SERVICE MANUAL

Matrix-12

OBERHEIM

ENGINEERING CHANGE ORDER

-SCHEMATIC-
MATRIX-12 PROCESSOR BOARD
VELOCITY KEYBOARD SCANNER

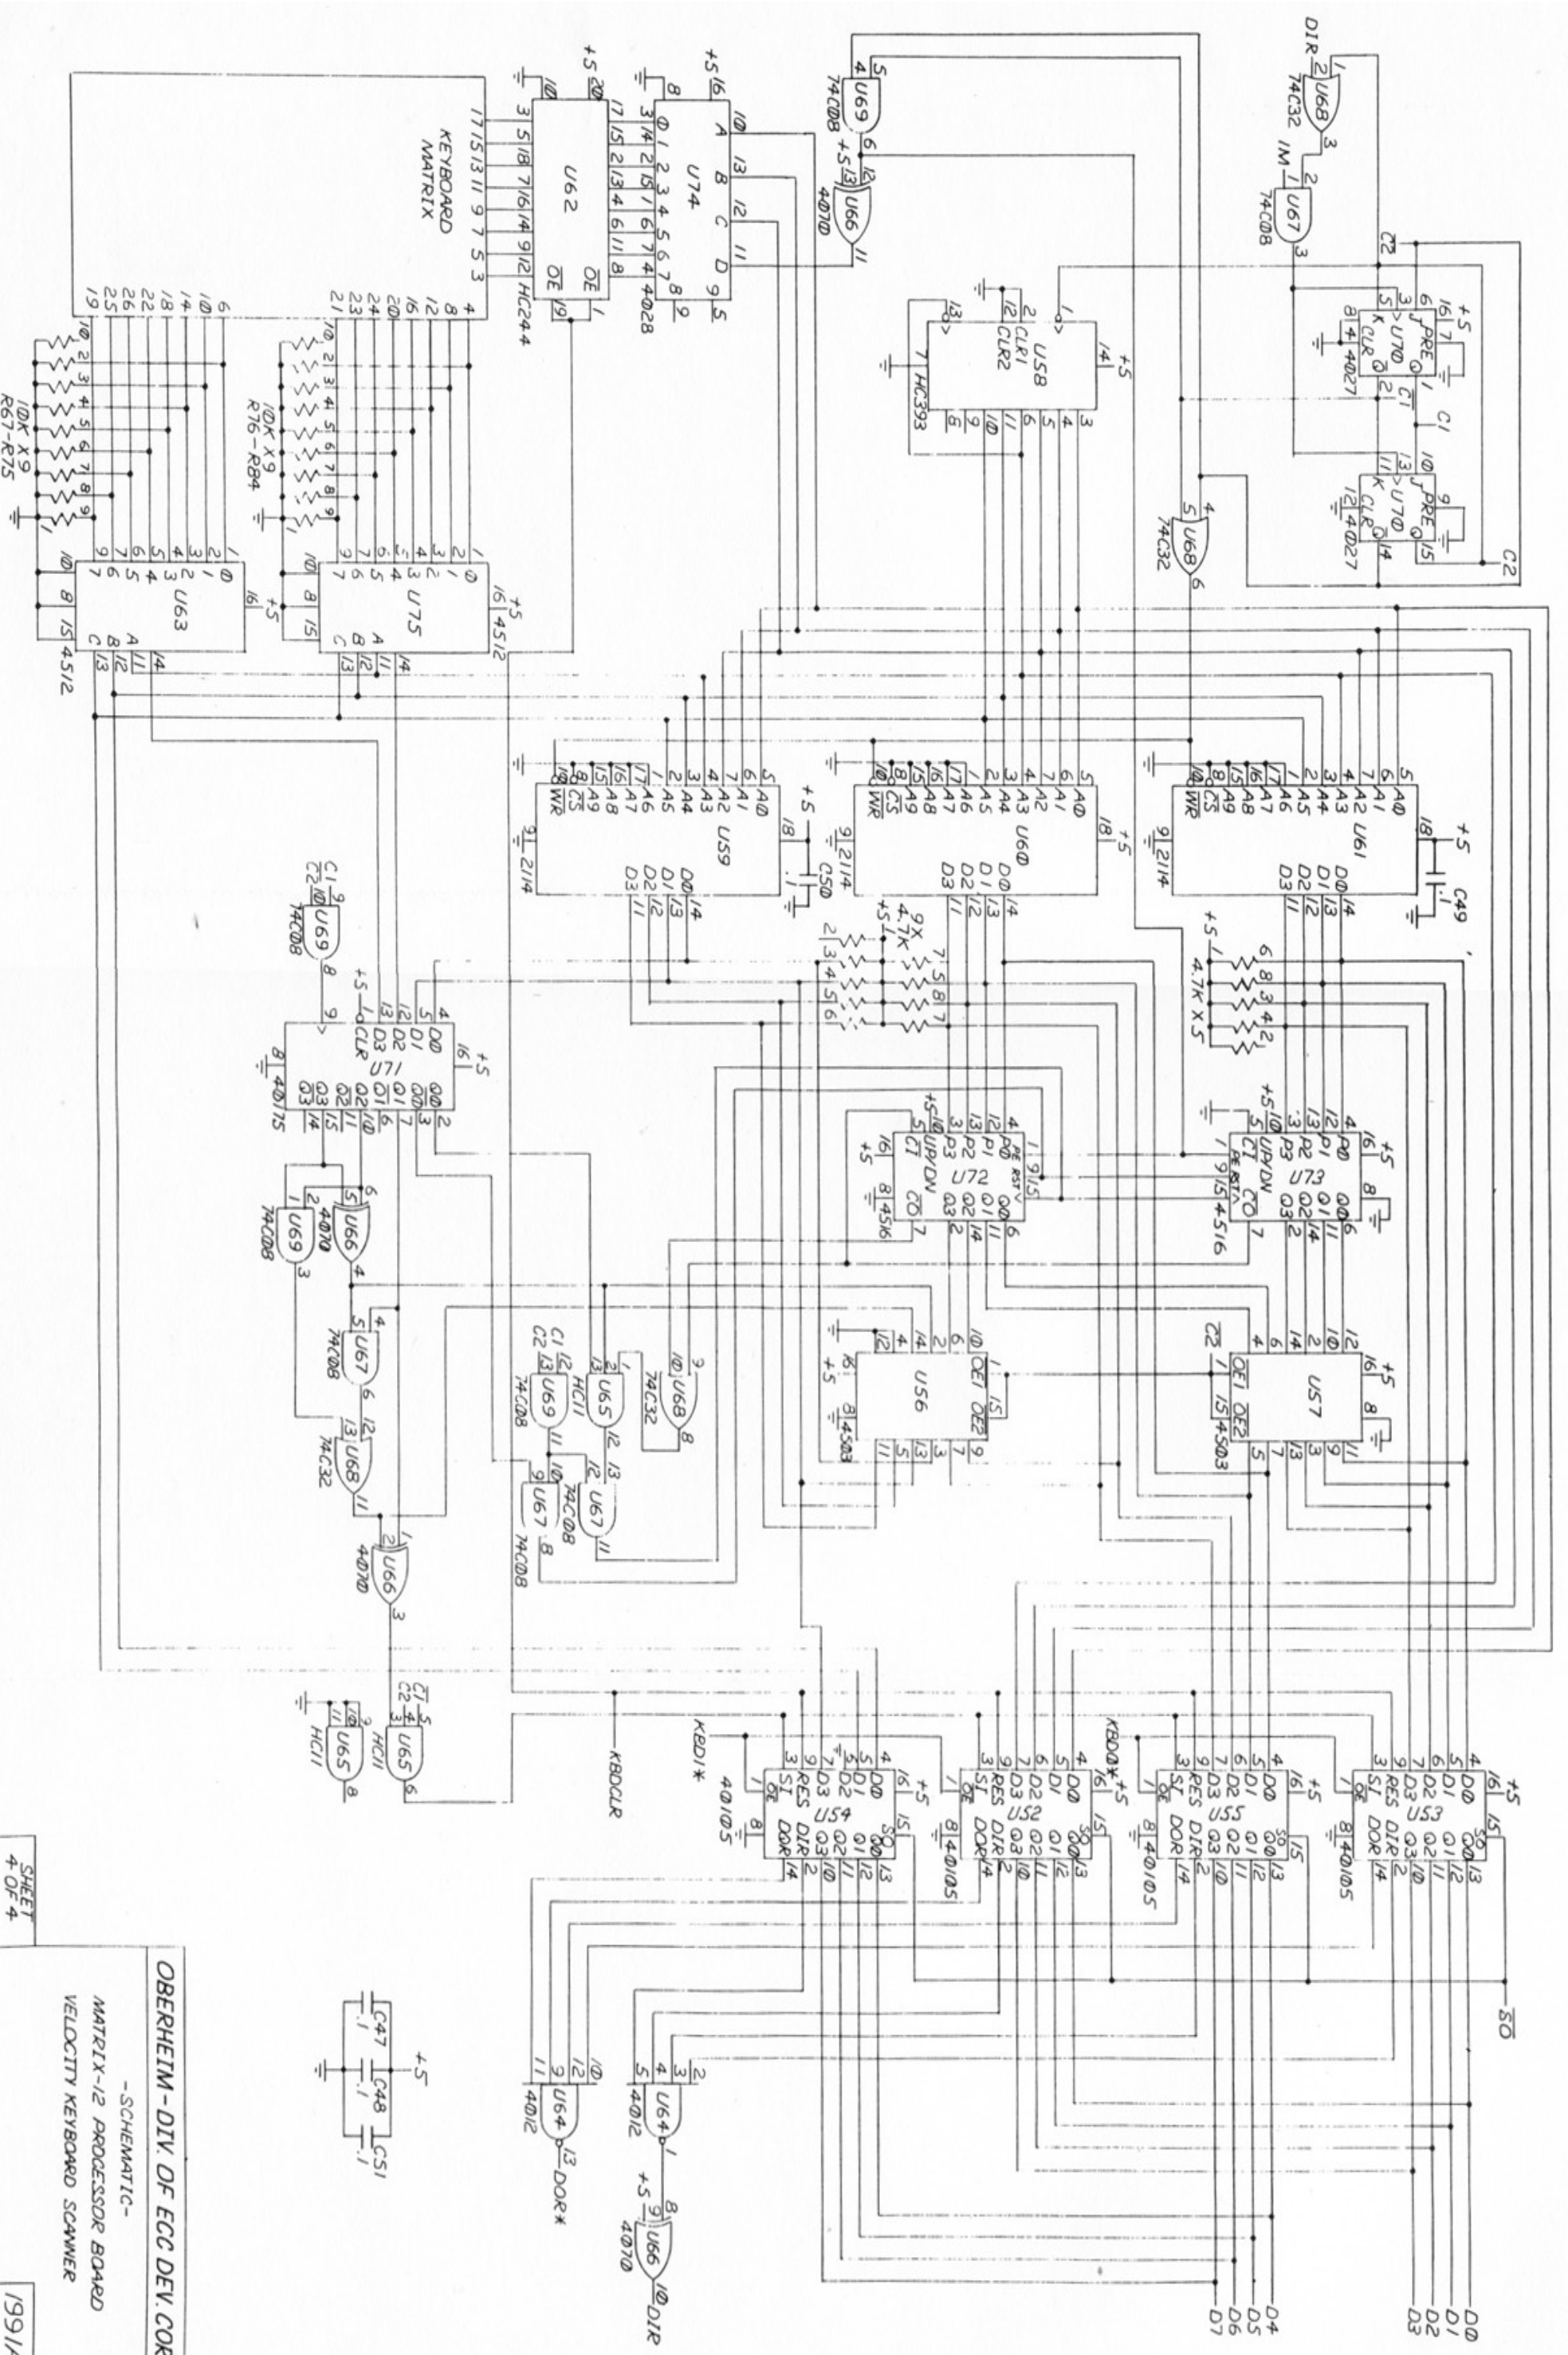
TO ELIMINATE THE POSSIBILITY OF THE CLOCK CABLES BECOMING DISCONNECTED FROM THE PROCESSOR BOARD WHILE IN TRANSIT.

- 1. MODIFY TWO CABLE ASSEMBLIES #4 (OBERHEIM PART #750185-0) BY REMOVING ONE OF THE TWO 3 PIN MOLEX CONNECTORS ON EACH SO THAT THERE IS A CONNECTOR ON ONLY ONE END OF EACH CABLE .**
- 2. REMOVE THE 3 PIN MALE MOLEX CONNECTORS (OBERHEIM PART #219340) ON THE MATRIX-12 PROCESSOR BOARD (720102) AT CONNECTOR LOCATIONS D AND E.**
- 3. SOLDER THE BARE WIRE END OF CABLE ASSEMBLIES TO THE PROCESSOR BOARD AT LOCATIONS D AND E. THE SHIELD OF ONE OF THE CABLES SHOULD BE SOLDERED TO PIN 1 OF CONNECTOR D, AND THE CENTER CONDUCTOR OF THE SAME CABLE SHOULD BE SOLDERED TO PIN 2 OF CONNECTOR D. THE OTHER CABLE SHOULD BE CONNECTED IN THE SAME MANNER TO CONNECTOR E.**
